Access Compliance Report

Public Rights-of-Way

(Curb Ramps)

Intersection ID: 28446	Main Street: SHINING_OAK_LN	Cross Street: SUMMER_CREEK_LN	Location:	N/A
ADA ID: 3869762AC92F	Ramp Type: Para	Initial Pass/Fail: Fail	Overall Compliance: No	Severity Score: 12.5
Codes/Mitigation Info/Possible Solution		Field Measurements/Component Compliance

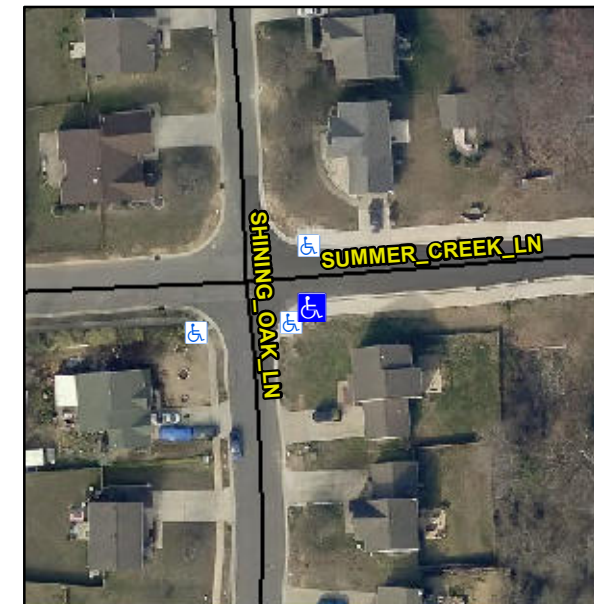
LT RP < 5%

R304.3.2

Compliance	Description	Data	Compliance	Description	Data
N/A	Ramp Length LT (in)	70.5	N/A	Ramp Length RT (in)	46.0
Yes	Ramp Width LT (in)	83.5	Yes	Ramp Width RT (in)	84.5
Yes	Ramp Slope LT (%)	1.7	No	Ramp Slope RT (%)	8.6
Yes	Ramp XSlope LT (%)	0.5	Yes	Ramp XSlope RT (%)	0.6
N/A	Landing Length (in)	N/A	N/A	DWS Provided?	N/A
N/A	Landing Width (in)	N/A	N/A	DWS Contrast?	N/A
N/A	Landing Slope (%)	N/A	N/A	DWS Length (in)	N/A
N/A	Landing X Slope (%)	N/A	N/A	DWS Full Width?	N/A
N/A	Landing Curb? (Y/N)	N/A	N/A	DWS Offset (in)	N/A
N/A	Shared Landing?	N/A			
N/A	Gutter Ponding?	N/A	N/A	Gutter Slope (%)	N/A
N/A	Gutter Lip Ht (in)	N/A	N/A	Gutter X Slope (%)	N/A
N/A	Painted X Walk1?	No	N/A	Painted X Walk2?	N/A
	X Walk 1 Direction	To N		X Walk 2 Direction	N/A
N/A	X Walk 1 Width (in)	N/A	N/A	X Walk 2 Width (in)	N/A
	X Walk 1 Slope (%)	N/A		X Walk 2 Slope (%)	N/A
	X Walk 1 X Slope (%)	N/A		X Walk 2 X Slope (%)	N/A
N/A	Ramp inside XWalk1?	N/A	N/A	Ramp inside XWalk2?	N/A

Remove & Replace Entire Ramp.
